**RICHLAND COUNTY
PLANNING COMMISSION**

MAY 3, 2004

**RICHLAND COUNTY PLANNING &
DEVELOPMENT SERVICES DEPARTMENT
PLANNING COMMISSION SUBDIVISION STAFF REPORT**

Applicant: Jim Mayes		Preliminary Subdivision Plans For: Cedar Heights	
RC Project # : SD-04-199			
General Location: NW Corner of Alpine Road & Old Percival Road			
Tax Map Number: 19712-03-30 & 19809-04-05		Current Zoning: RG-2	
Subject Area: 12.8 acres	Number of Parcels: 98	Gross Density: 7.6 DU/acre	
Sewer Service Provider: East Richland		Water Service Provider: City of Columbia

STAKING PLAN

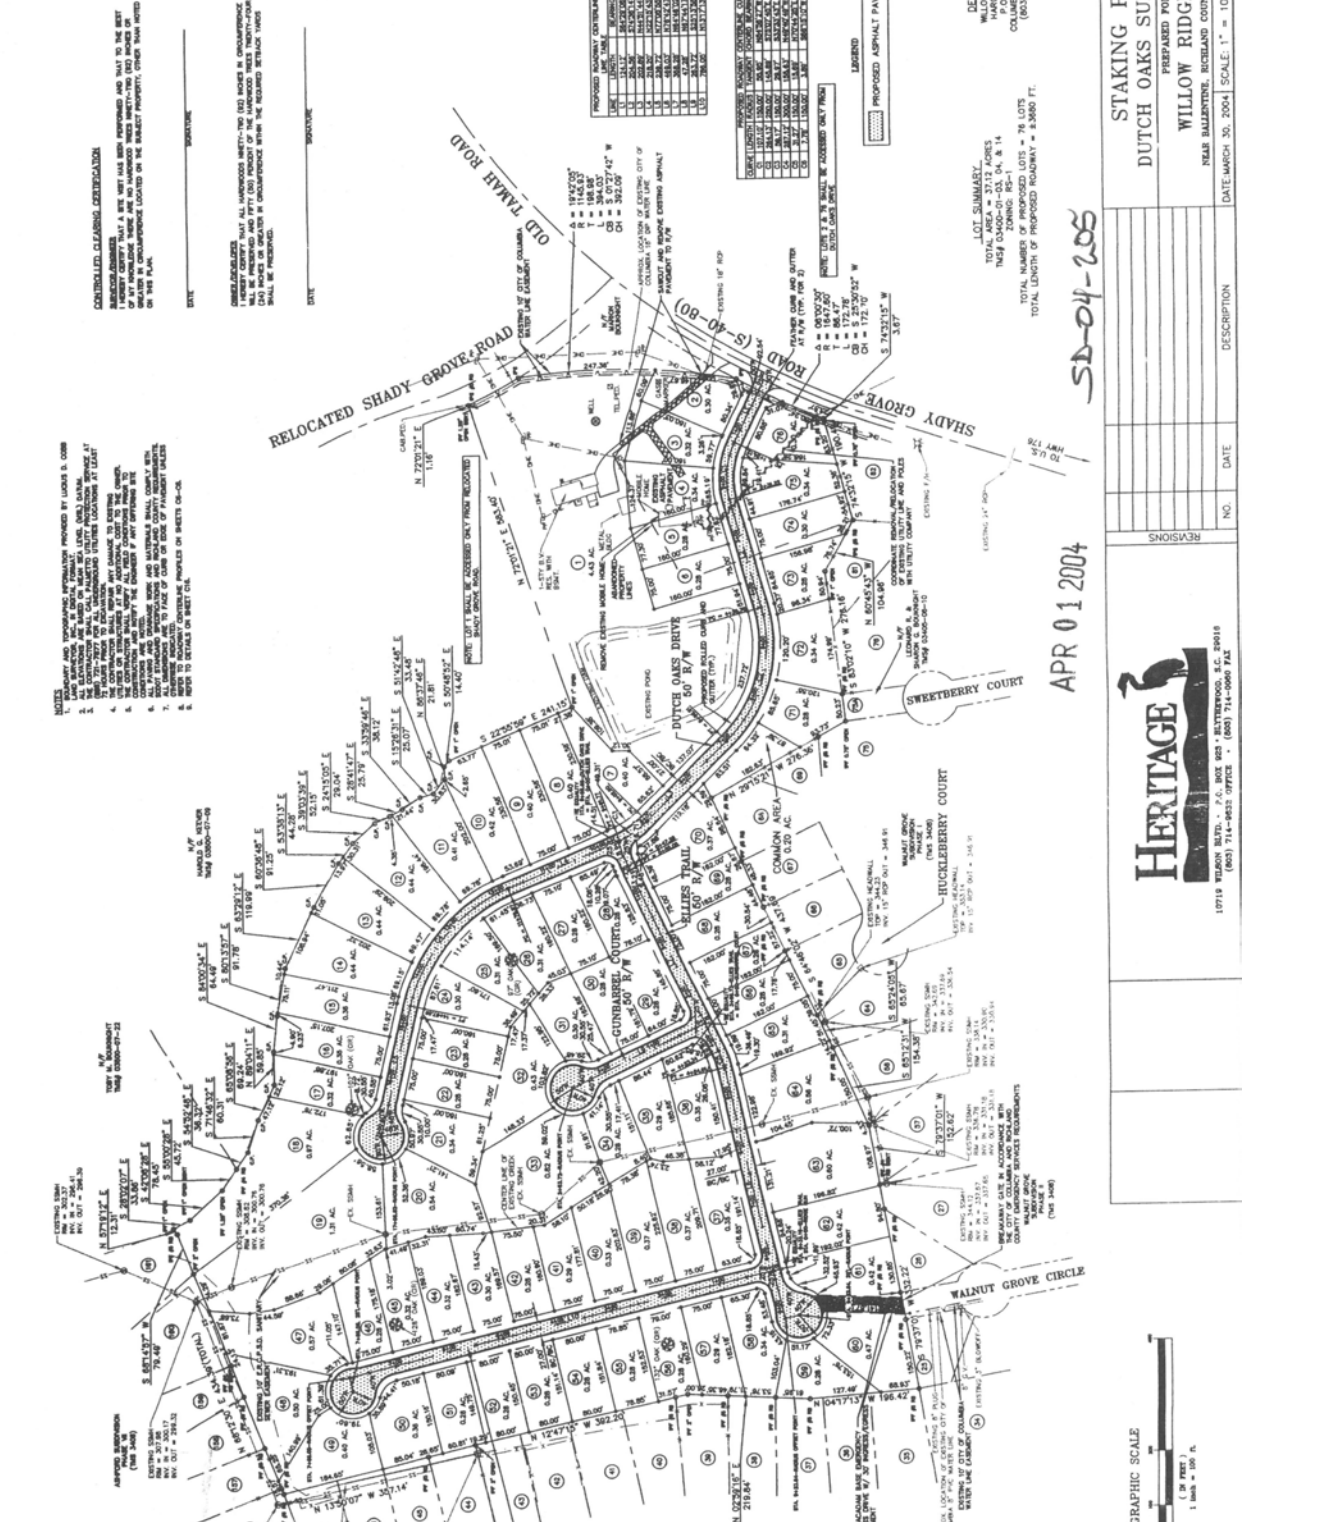
- 1) As of April 16, 2004, the Public Works Dept. had not approved the stormwater management plans.
- 2) On March 29, 2004, the Flood Hazard Manager stated, “...**The flood elevation statement was disapproved.** A flood discharge elevation study is required on the creek and the pond... “(Sketch Plan comments provided to the applicant on March 15, 2004 required flood elevation approval)

- 3) The County Fire Marshal commented, “ This site plan is approved as ordered. As a result of the number of lots exceeding 30, two separate and approved fire apparatus access roads shall be required. Where two access roads are required, they shall be placed a distance apart equal to not less than one half the length of the maximum overall diagonal dimension of the property served. When a fire hydrant is located on a fire apparatus road, the width shall be 26 ft. The minimum turning radius for a cul-de-sac shall not be less than 45 ft...” (Sketch Plan comments provided to the applicant on March 15, 2004)

The preliminary plans submitted by the applicant failed to comply with the Fire Marshal’s Sketch Plan comments (See above discussion) that the subdivisions streets must have a minimum of 26 feet of paving and have a secondary access point. The plans also failed to comply with the Fire Marshal’s comments for a minimum radius of 45 feet of paving in the cul-de-sacs. The plans show a 40-foot paving radius.

- 1) The flood elevation statement submitted with the application material was disapproved.
- 2) The preliminary plans do not comply with the Fire Marshal’s road paving and access requirements identified in the Sketch Plan comments.

Based on the findings of fact summarized below, the Planning and Development Services Department (PDSD) recommends the Planning Commission **defer further consideration of this project until final adjudication of the various violations of the County Code, and state laws if applicable, is completed.**
